Revisions: 27.04.23 RESPONSE TO RFI KW

Project: **BALFOUR PLACE**

Drawing: **BASEMENT COMPARATIVE PLANS**

Drawing No: **RFI - 01**

Drawing / LOWER GROUND 1
COMPARATIVE PLANS

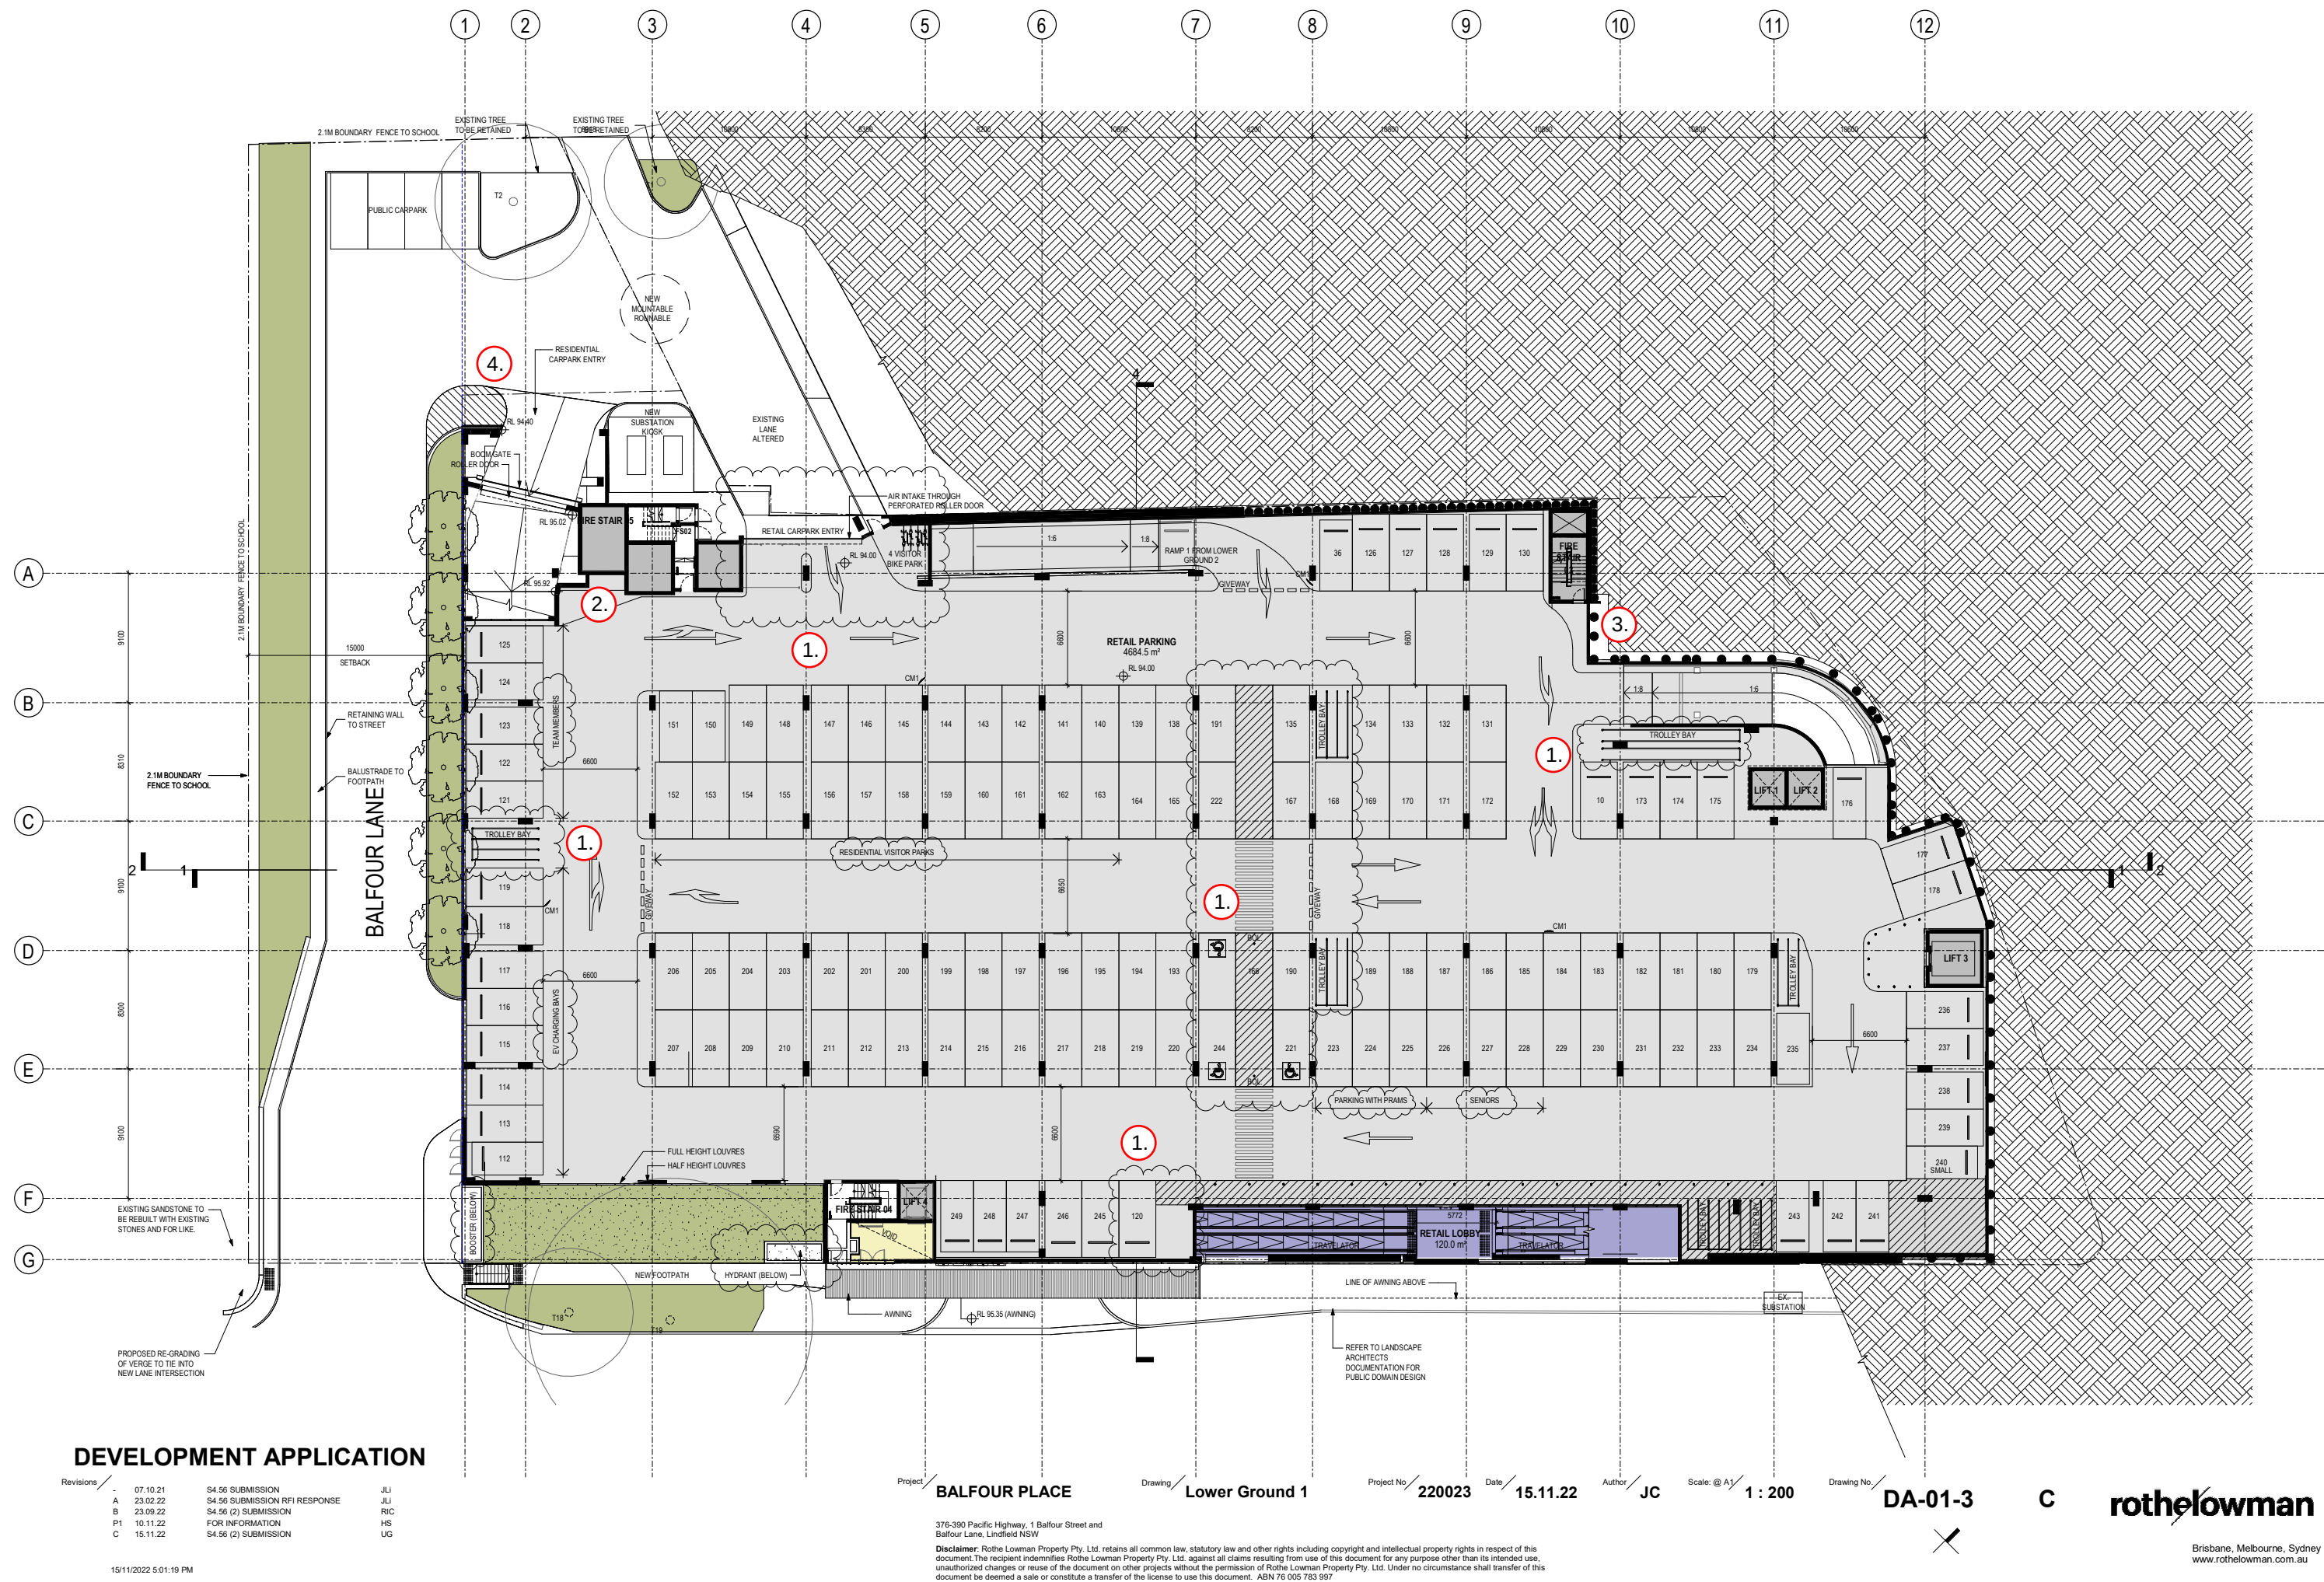
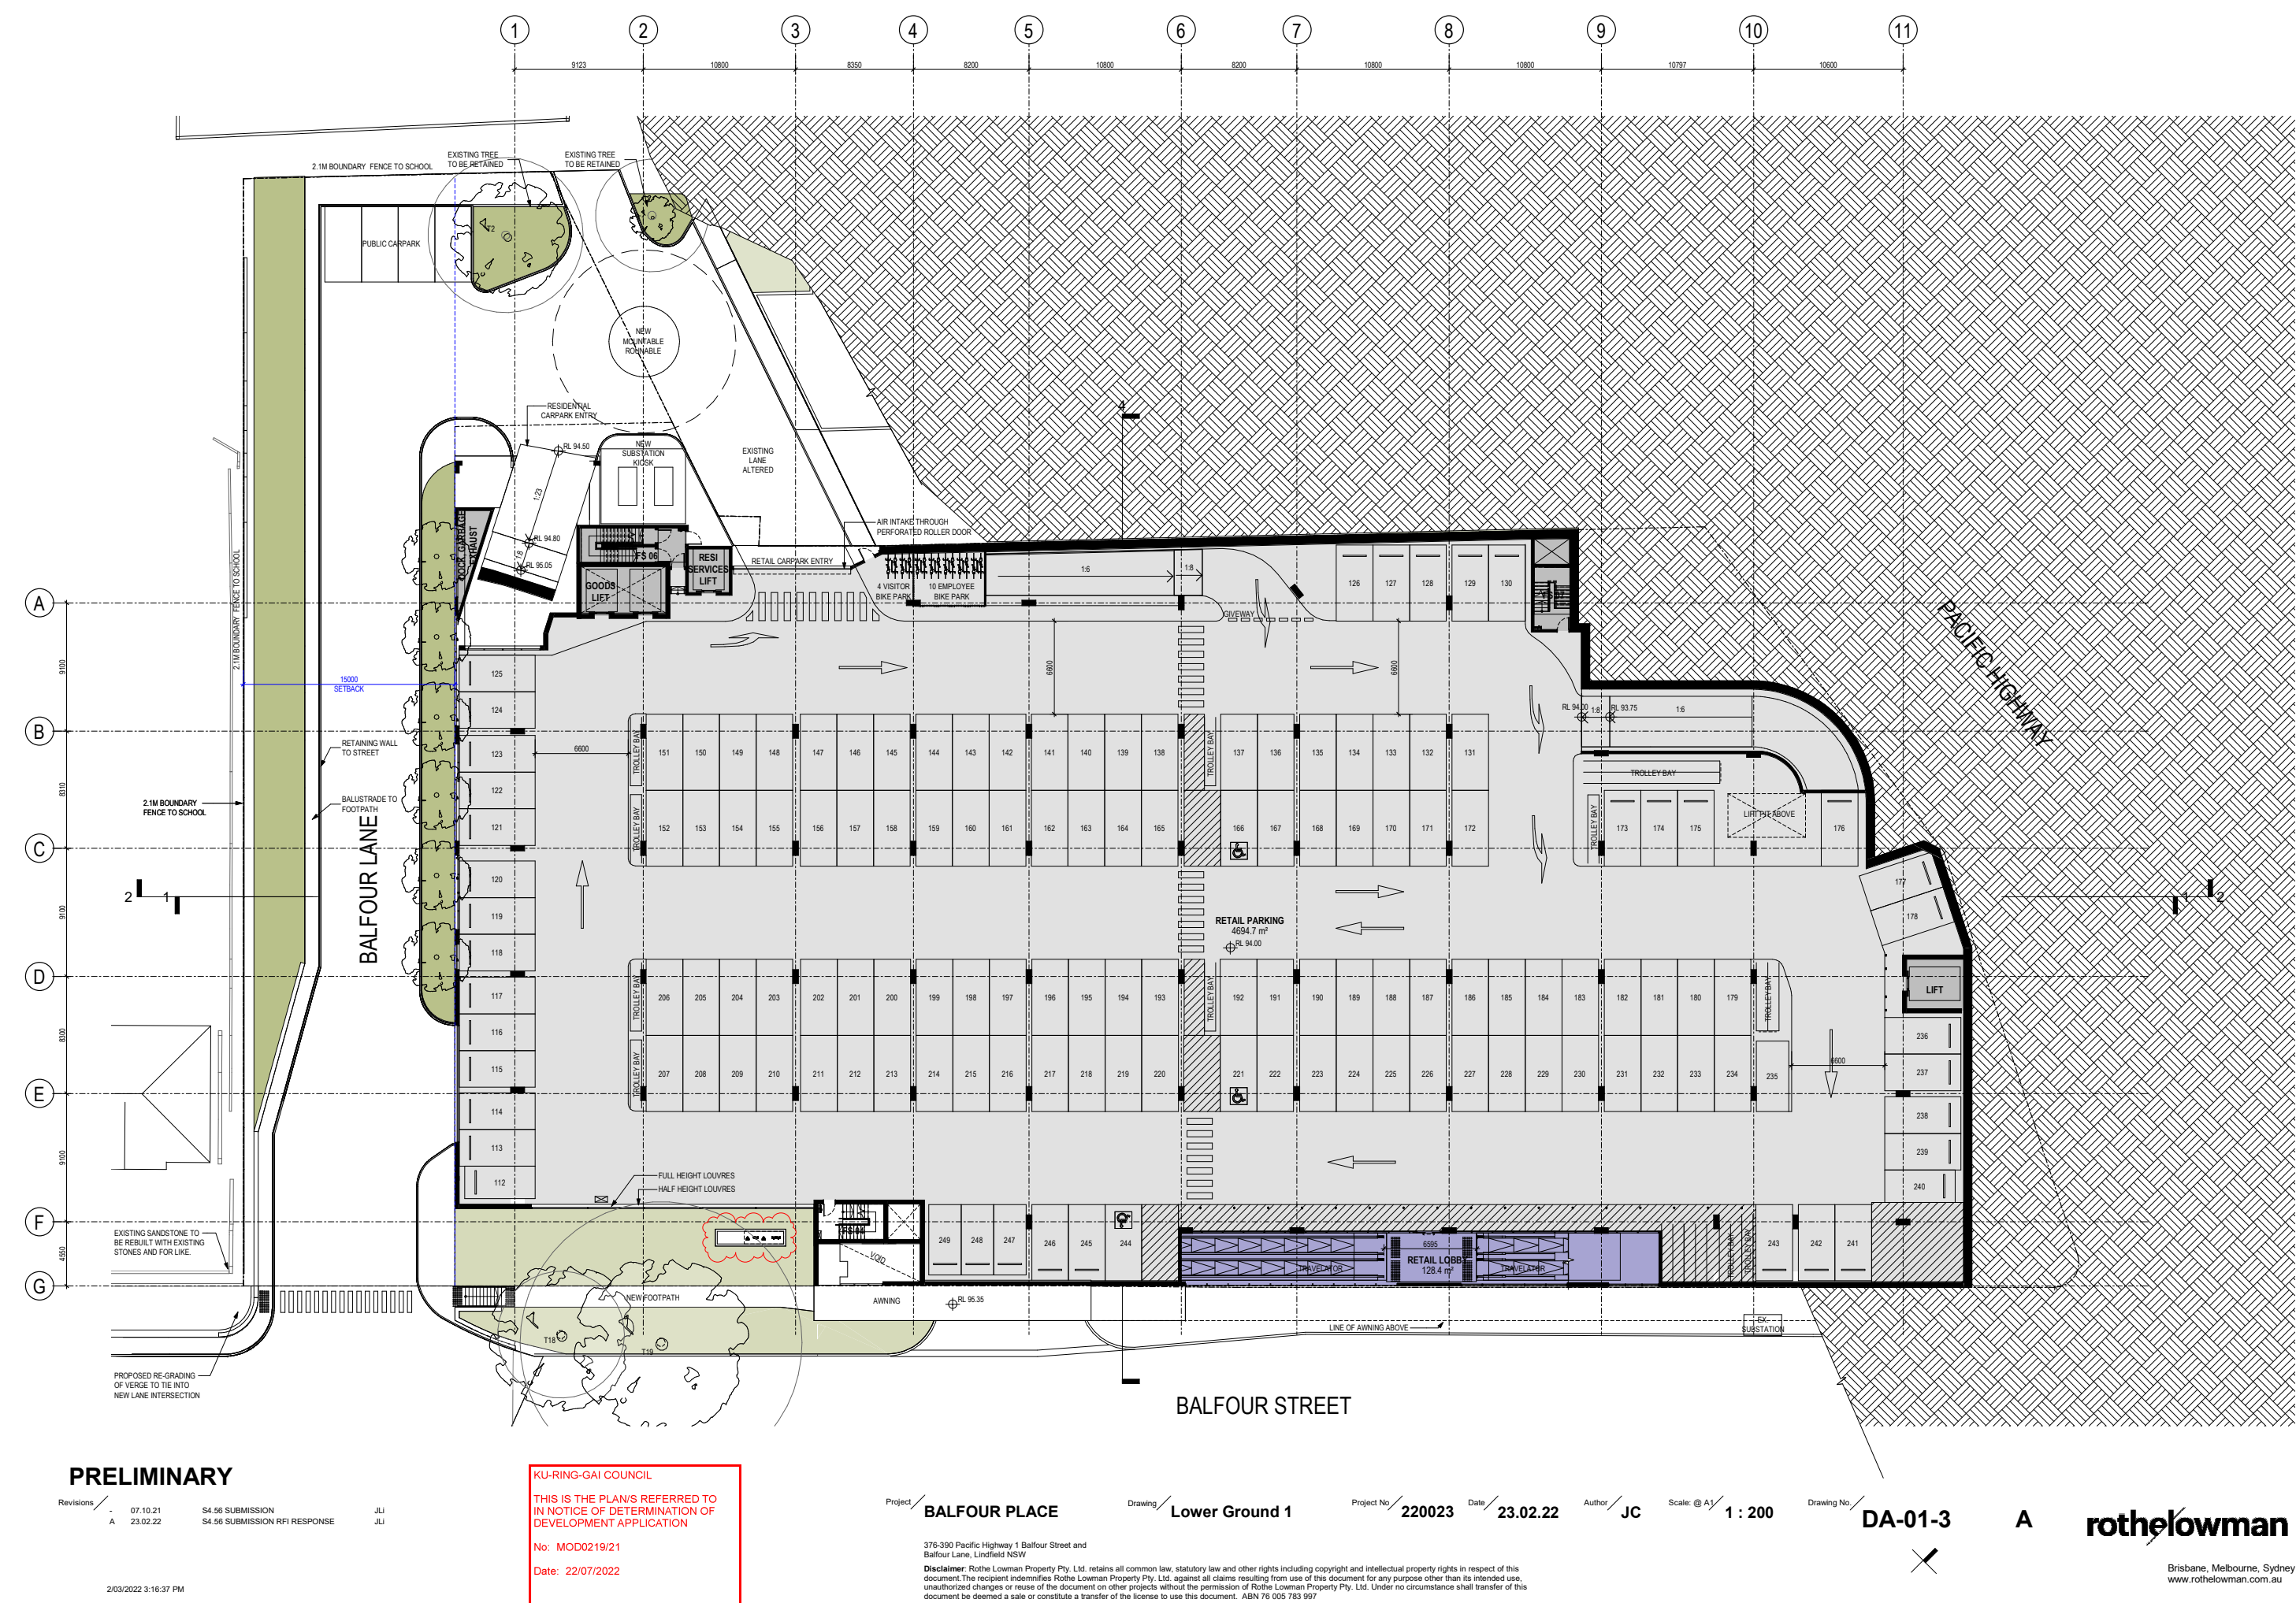
1. RETAIL CARPARK LAYOUT CHANGES - REDUCTION IN CARS (TROLLEY BAYS)
2. COLES GOODS LIFTS AND ASSOCIATED FIRE STAIR LAYOUT UPDATED
3. RATIONALISE SHORING
4. MINOR DEMOLITION OF EXISTING KERB FOR SWEEPED PATH - CARPARK ENTRY

Drawing: **LEVEL 2**
COMPARATIVE PLANS

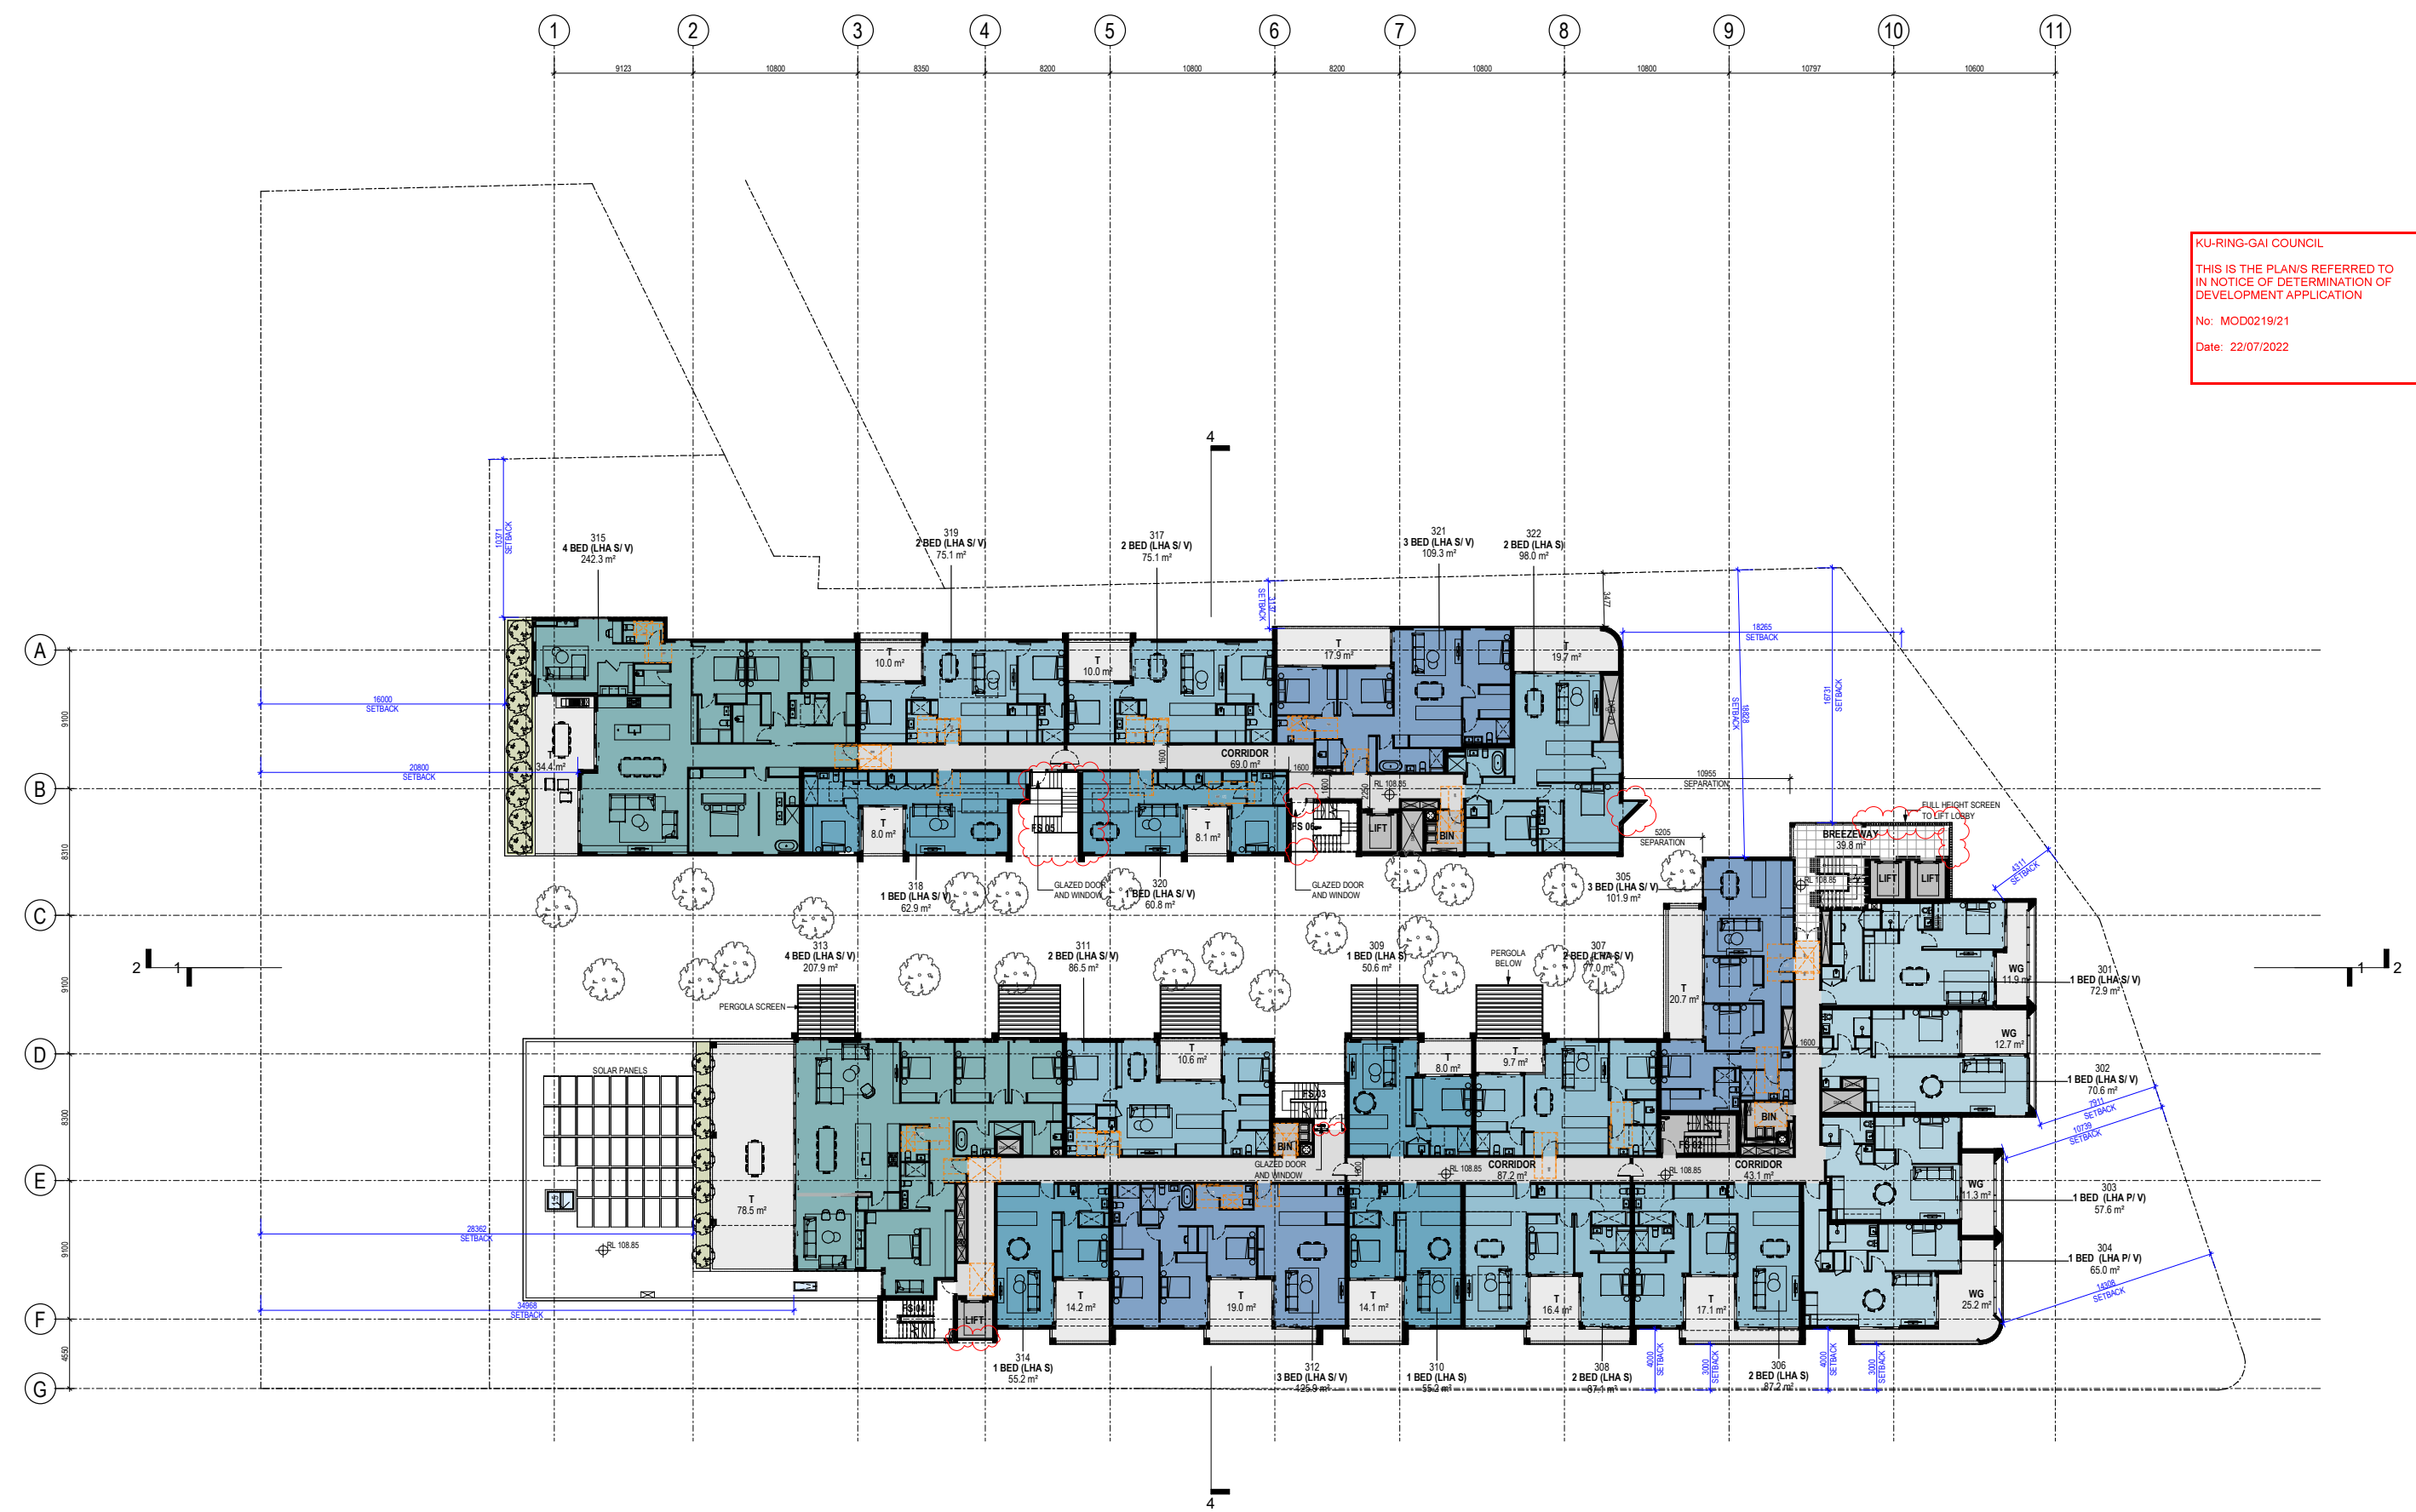
1. RESIDENTIAL SERVICES LIFT OVERRUN AND ASSOCIATED CHANGES TO FACADE
2. INTERNAL APARTMENT LAYOUT CHANGES
3. DRYING AREA RELOCATION
4. ADDITIONAL COLUMN FOR STRUCTURE
